Product hierarchy no. *				Part no.	SBU	Type / Description	Customer part no.
SBU	PG	PGU	Type				
02	006	016	0000001606	See list below	Power Entry Module with Filter	5123

Implementation of V-Lock cord retaining feature as standard.

Product Change Notification					PCN 5123 with V-Lock		
owner	creation date	release date	released by	change order no	rev	page	D10-006-438
sariogar	04.06.2018	11.06.2018	blumhe	2015515	B	1 of 2

Old product appearance	New product appearance
<p>Protection class I</p> 	<p>Protection class I</p> 
<p>Protection class I</p> 	<p>Protection class I</p>

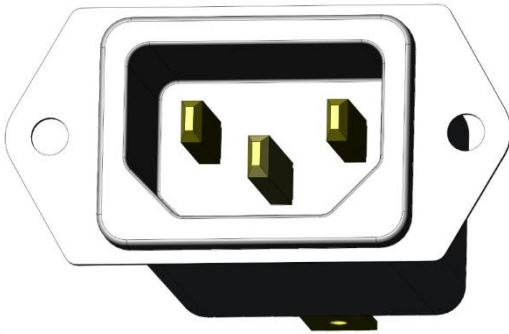
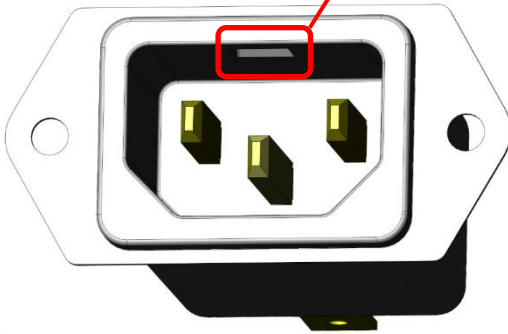
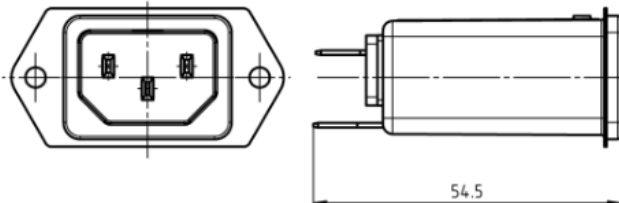
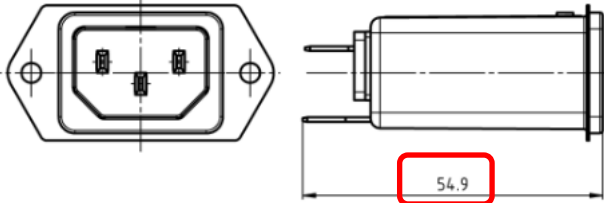
V-Lock feature integrated as standard (not an option anymore) .

Form	Yes	Socket has notch for V-Lock cord
Fit	Yes	Installation depth is 0.40 mm extended
Function	Yes	V-Lock feature is standard (not an option anymore)
Production Site	No	There is no change of the production site
Product Label	No	There is no change on the label
